MEMO

TO	Peter Greene / Mt Iron Junction Limited	DATE	20/07/2026
CC	Charlotte Coyle / Lane Neave	OUR REF	P240103
FROM	Peter Joyce / Senior Surveyor/ Land Development Engineer		
REVIEWED	Duncan White/ Planner		
RE	Mt Iron Junction – Response to Minute 5 of the Expert Panel - Shared Path Costing

2. Transport Issues [3](a)(iv) (1) Active Travel Links

Diagram 2 – Mt Iron Junction Active Transport Links Excerpt – P240103 - Sheet 350 – 15/07/2026

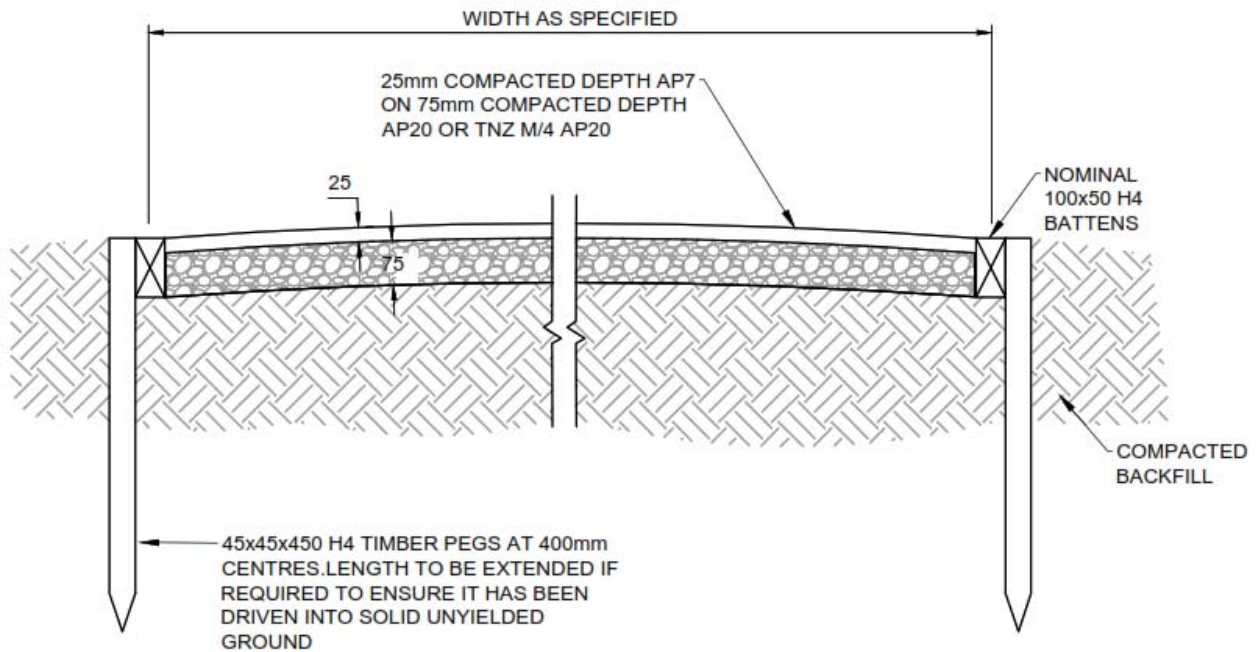
Diagram 2 (also provided as **Appendix A**) shows an active transport link (shown **A**) from the existing Wānaka – Albert Town Active Link from the Aubrey/Old Racecourse Road intersection to the northern corner of the site. Section **A1** is the length on Aubrey Road and Section **A2** is the length on SH6. This active transport link then enters the site and extends down the eastern side of Junction Road as a 3m wide sealed shared path (Section **B**). Sections **C1** and **E2** are a new route following the former road alignment along the south-western boundary of the site to join with SH84. Section **C2** is an upgrade to the current informal cycle connection to the gravel cycle/pedestrian path at the base of Mount Iron and this will act as a recreational link from the site to the Mount Iron track. Section **E1** is a new section of active transport link that follows the recently laid underground trunk water and wastewater sewers to the former carpark opposite Puzzling World before joining the existing Wānaka – Albert Town Active Link and following this (Section **D1**) to the SH84 pedestrian and cycle underpass to Three Parks.

Sections **D1** – **D4** show the existing Mount Iron track connection through to Aubrey Road.

This plan duplicates the travel routes associated with the development provided by NZTA apart from the link shown from the junction of E1 and E2 to join into the development at the end of Mountain Road West.

I have not shown this additional link from the highway edge to the cul-de-sac head at the southern end of Mountain Road as the separation between the site boundary and seal edge is insufficient to accommodate a 2.5m wide path along with stormwater swales.

Active Transport Links Plan

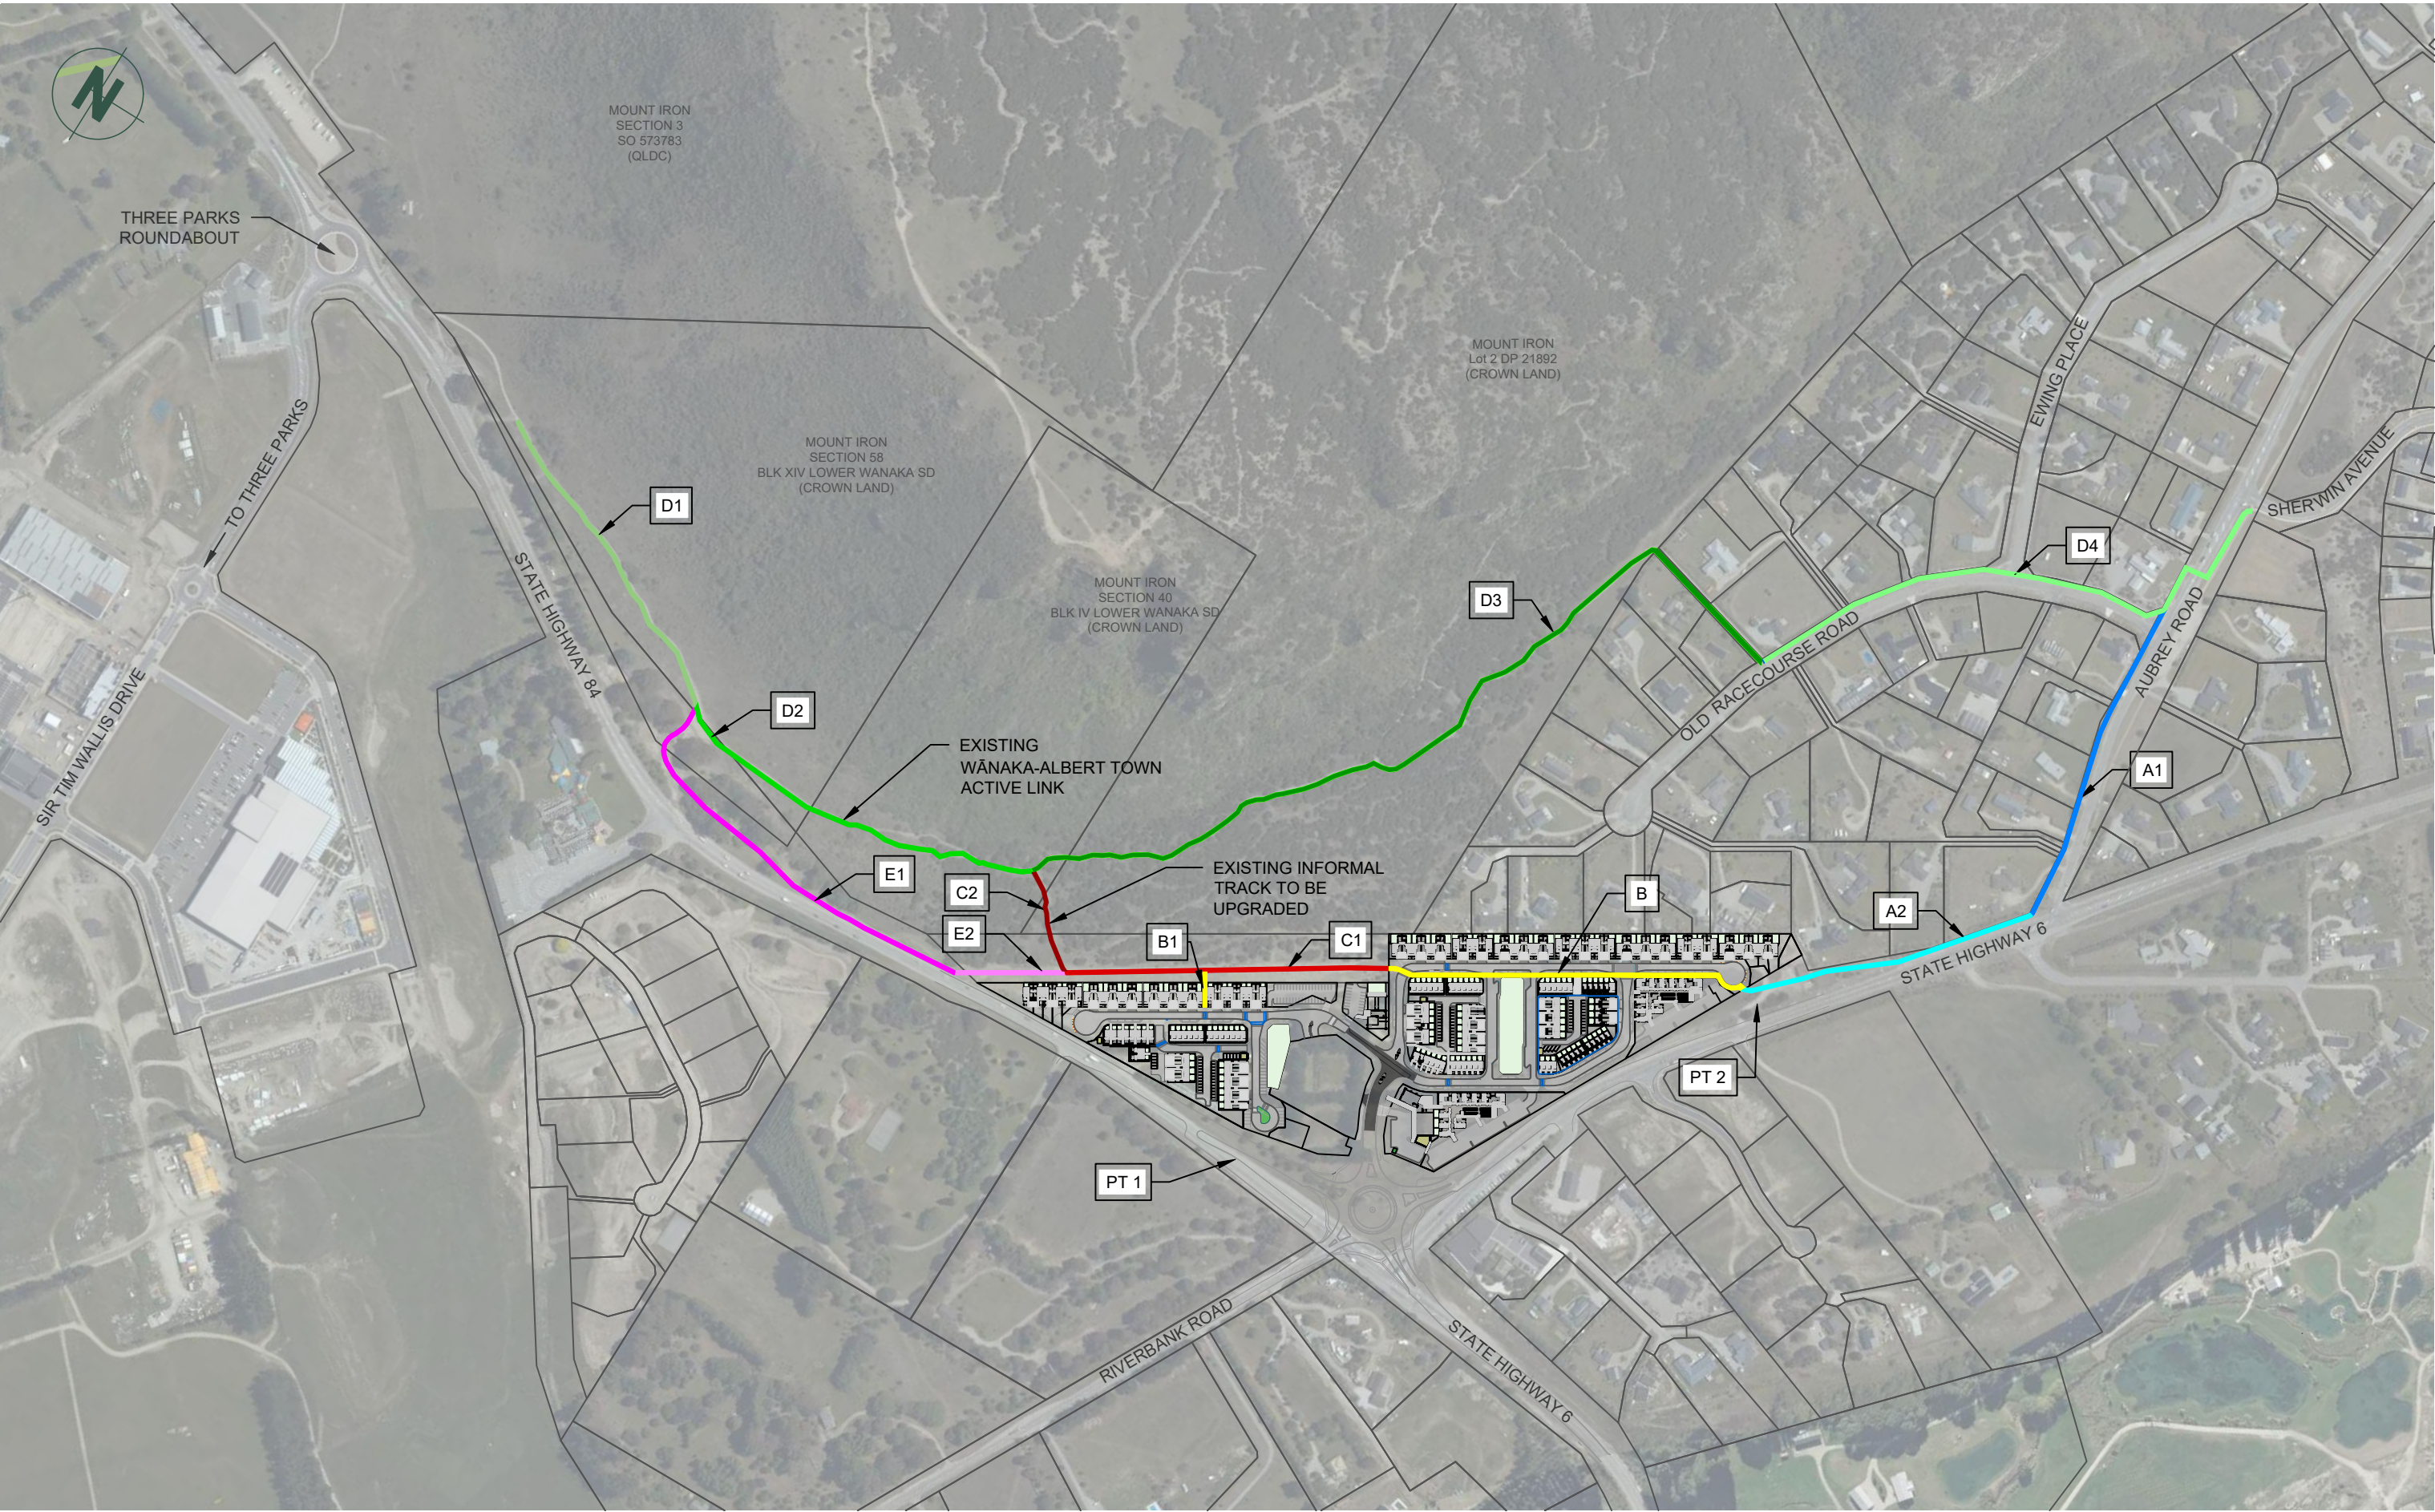
An additional drawing (Sheet 350) has been added to the drawing set to show active travel links relevant to the site. The locations of these paths were identified in the 2018 Wanaka Network Operating Framework (NOF) and then updated as part of the Wanaka Network Optimisation Business Case (WNOBC) document as presented to the Wanaka Upper Clutha Community Board in August 2025 (see Diagram 1 – below). The relevant active link around the highway boundaries of the Site is identified as route 5. On this topic it is noted the Panel's preference in the second bullet point at the bottom of page 3 of Minute 5 that *"... the Panel confirms that it agrees in principle with the Applicant that, to the extent possible than any pedestrian/cycle routes for the public align with the Site rather than following the outer boundaries of the Site around the highways and exposed to the roundabout."*

I have however identified two locations where future bus stops could be accommodated. These are shown as PT1 and PT 2 on Drawing 350 which do not conflict with potential path alignments.
